SUBJECT: Appeal to Requirement to Guarantee for Extension of Municipal Water

RE: S/D 93-41 Plat of the Four Pines Ranch Addition

STAFF REPORT
(Final Plat)

CASE NUMBER: S/D 93-41 -FOUR PINES ESTATES ADDITION

VICINITY MAP:

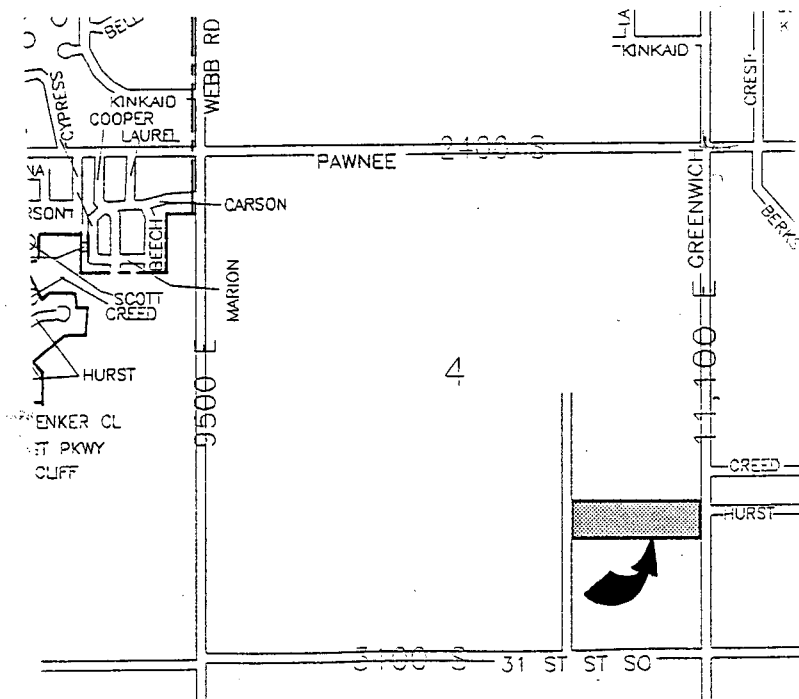
- A. Since neither municipal water nor sanitary sewer is available to serve this property, the applicant shall contact the Environmental Health Division of the Health Department to find out what tests may be necessary and what standards are to be met for approval of on-site sewerage facilities and water wells. A memorandum shall be obtained specifying approval.

- B. The applicant shall guarantee any drainage improvements required by the platting of this property.
- C. Since this plat appears to be dedicating right-of-way for Greenwich Road, such dedication shall be clearly noted on the face of the plat and such dedication of right-of-way to and for the use of the public shall also be indicated in the plattor's text.

- D. The dedication of access control to Greenwich Road shall also be indicated in the plattor's text. Since openings are being requested to Greenwich, the word "complete" shall be deleted from the face of the plat.

County Engineering needs to indicate if the two indicated openings to Greenwich are acceptable.
- E. Approval of this plat will require a waiver of the lot depth to width ratio of the Subdivision Regulations. The Subdivision Regulations state that, "the maximum depth of all residential lots shall not exceed 2-1/2 time the width thereof."

- F. County Engineering needs to indicate if a covenant is required concerning the ownership and maintenance of the floodway reserve and the County's right to enter this reserve and charge back any maintenance costs to the property owners(s).

- G. On the final plat tracing, a 35-foot building setback shall also be indicated to 107th Street East, or along this plat's western property line.
- H. On the final plat tracing, the plattor's text shall be amended to note that any activities within the floodway reserve is to be approved by the appropriate "engineer": instead of the governing body.

- I. The applicant shall indicate the name intended for this Addition. On the application, the addition name is

indicated as Four Pines Ranch. On the plat, instead of Ranch, Eastates is indicated. However, the spelling of Eastates appears to be a misspelling of Estates. The final plat tracing shall indicate the proper name intended for this plat.

- J. The applicant shall install or guarantee the installation of all utilities and facilities which are applicable and described in Article 8 of the MAPC Subdivision Regulations.
- K. The applicant's engineer is advised that the Register of Deeds is requiring the name(s) of the notary public, who acknowledges the signatures on this plat, to be printed beneath the notary's signature.
- L. Perimeter closure computations shall be submitted with the final plat tracing. Section 5-101(c)
- M. Recording of the plat within 30 days after approval by the City Council.
- N. The representative from County Engineering should be prepared to comment on the status of the applicant's drainage plan.
